September 12, 2011
U7-C-NINA-NRC-110116

South Texas Project
Units 3 and 4
Docket Nos. 52-012 and 52-013
Supplemental Response to Request for Additional Information

RAI 03.08.04-30, Supplement 6**QUESTION:****Follow-up to Question 03.08.04-23**

RAI 03.08.04-34, Supplement 1**QUESTION:**

Figure 03.08.04-30 S6.1

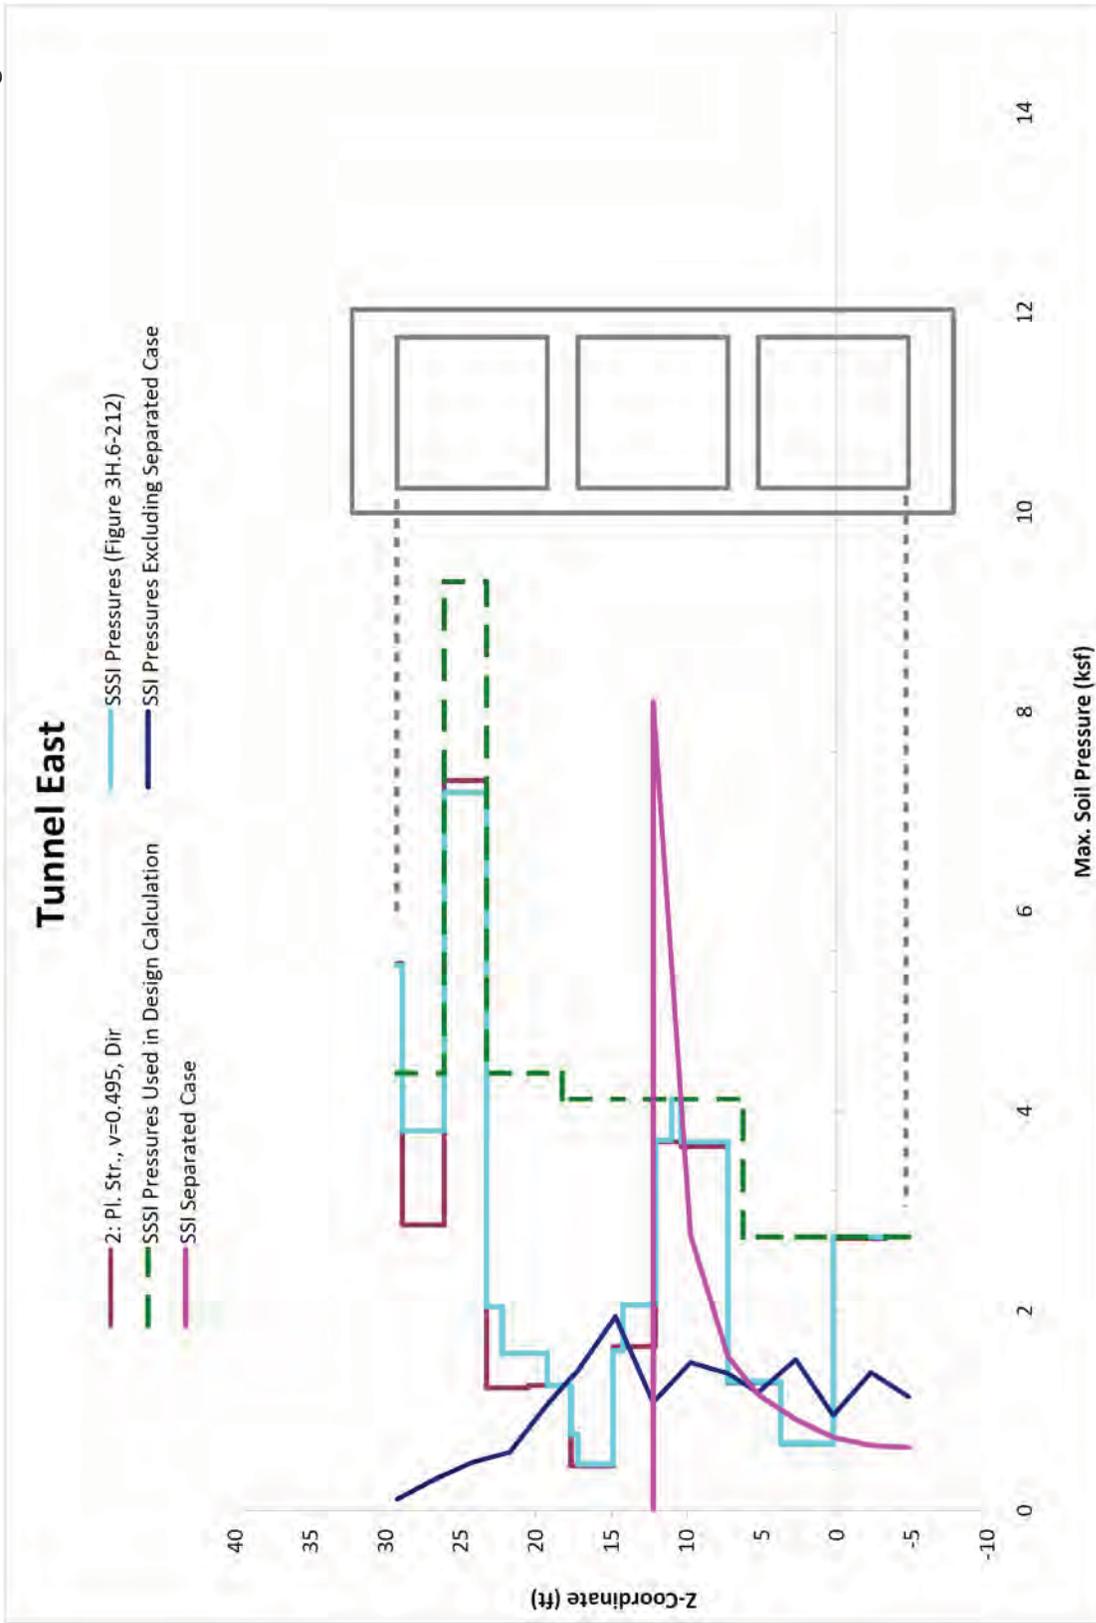
Provide SSI soil pressures for the RSW Tunnel

Figures 03.08.04-30 S6.1 and 03.08.04-30 S6.2 provide SSI and SSSI soil pressures on RSW Piping Tunnel east and west walls, respectively. Also shown in these figures are the seismic soil pressures used for the design of these walls. As shown in these figures, the seismic soil pressures used for design envelope all SSI and SSSI soil pressures except for a small portion along the wall height where SSI soil pressure from separated soil case is higher. The tunnel wall design was controlled by passive pressure. Based on the following this local exceedance is found acceptable.

Due to total out-of-plane load including SSI soil pressure from separated soil case:

Maximum calculated out-of-plane shear, $V1 = 28.07$ kips/ft

Maximum calculated out-of-plane moment, $M1 = 124.53$ kips-ft/ft

Due to controlling total out-of-plane load:

Calculated out-of-plane shear, $V2 = 36.52$ kips/ft

Calculated out-of-plane moment, $M2 = 226.78$ kips-ft/ft

As shown above, $V1 = 28.07$ kips/ft is less than $V2 = 36.52$ kips/ft and $M1 = 124.53$ kips-ft/ft is less than $M2 = 226.78$ kips-ft/ft. Thus, the design is conservative for separated soil case.

Figure 3H.6-248: RSW Tunnel Plan View

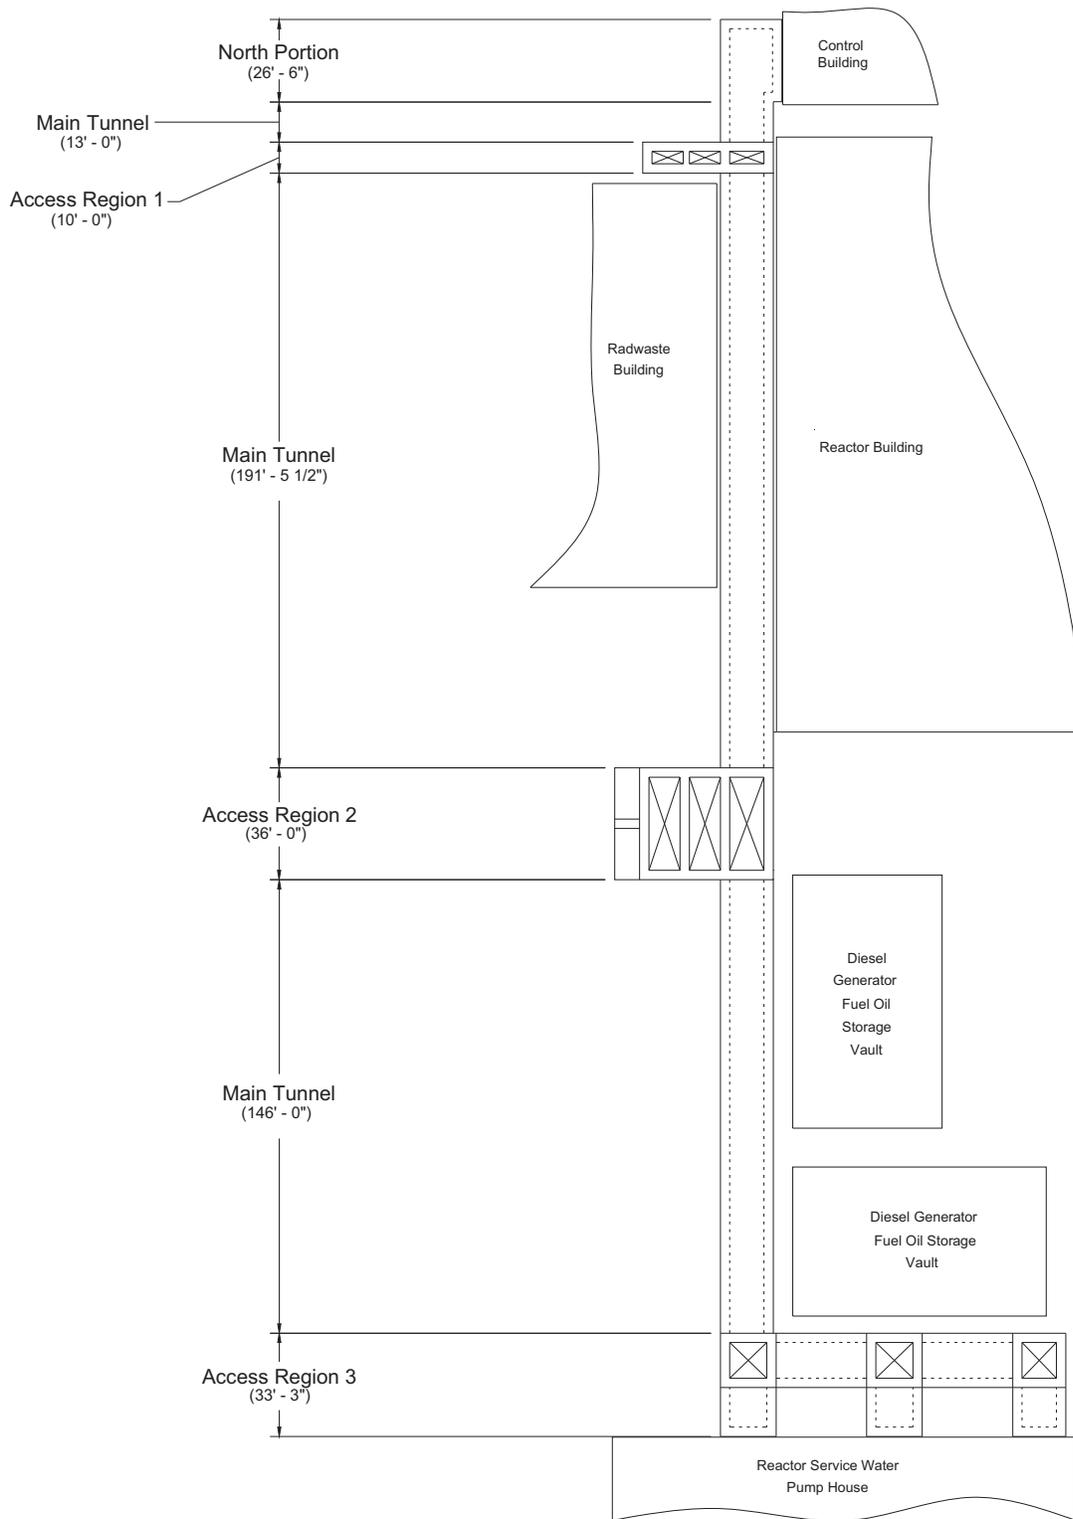
- (a) Table 3H.6-6, "Results of RSW Piping Tunnel Design", discuss the small differences between Required vs. Provided Reinforcement (0.7 versus 0.79 or 0.97 versus 1.00) or non-existent (1.56 for both).*
- (b) Check see if Note 3 in Table 3H.6-6 is clear as written.*
- (c) Determine if there is a sketch defining the reinforcing zones in the RSWPT*
- (d) In Figure 3H.6-247, is the passive pressure shown applicable to the entire RSWPT design?*

- Part a) In all cases the provided reinforcement equals or exceeds the required reinforcement. This meets the code requirements. Also, in determining the required reinforcement for RSW Piping Tunnel shown in Table 3H.6-6, in order to provide additional margin, the calculated moments and axial forces were divided by 0.9 (i.e. increased by $1/0.9 = 1.11$). Therefore, as a minimum a margin of 11% is available.
- Part b) The notes of Table 3H.6-6 will be revised to further clarify this table (see Enclosure).
- Part c) Figure 3H.6-248 (see Enclosure) provides the RSW Piping Tunnel layout and reinforcement zones.
- Part d) The passive pressure shown in Figure 3H.6-247 is applicable to the entire RSW Piping Tunnel design (i.e. main tunnel segments, north portion, and access regions 1, 2, and 3)

**Figure 03.08.04-34 S1.1: Partial Plan View of UHS Basin Basemat Mesh
Out-of-plane Shear Averaged over 2T
T = Basemat Thickness, 10 ft**

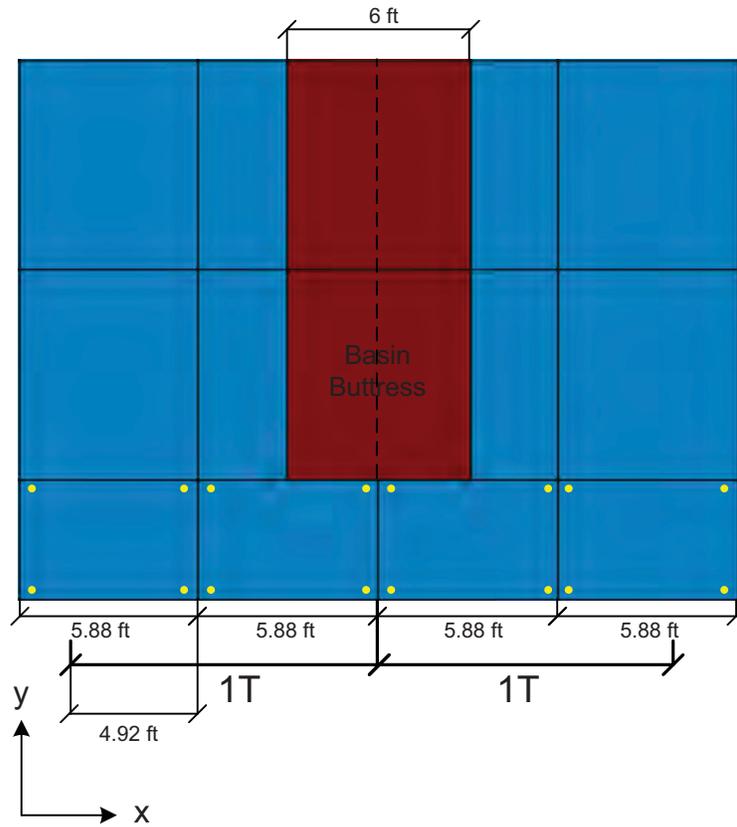
- Obtain clarification from the ACI regarding validity of use of Section 11.12 of ACI 349-87 for the situations where the provisions of the code were used,
- Provide examples of any precedence where similar methodology was accepted by the staff,
- Provide detailed justification using industry accepted standards, technical references, experimental results, etc., to justify redistribution of the shear forces obtained from finite element analysis.

No averaging has been used for out-of-plane shear design except at four locations within the UHS basin basemat at the junction of basin buttresses with the basin basemat. At these four locations, the out-of-plane shear was averaged over a total length of twice the basemat thickness (i.e. $2 \times 10 = 20$ ft, basemat thickness = 10 ft). This averaging of shear is justified for the following reasons:

- The local shear concentration is due to excessively refined mesh for a 10 ft thick mat. As can be seen from Figure 03.08.04-34 S1.1, the width of the basemat elements is only 5.88 ft.
- The basin buttresses are 6 ft thick walls. Considering a load distribution of 45° through the basemat thickness will yield an effective strip of 26 ft (i.e. $6 \text{ ft} + 2 \times 10 \text{ ft} = 26 \text{ ft}$) which exceeds the 20 ft used for shear averaging.
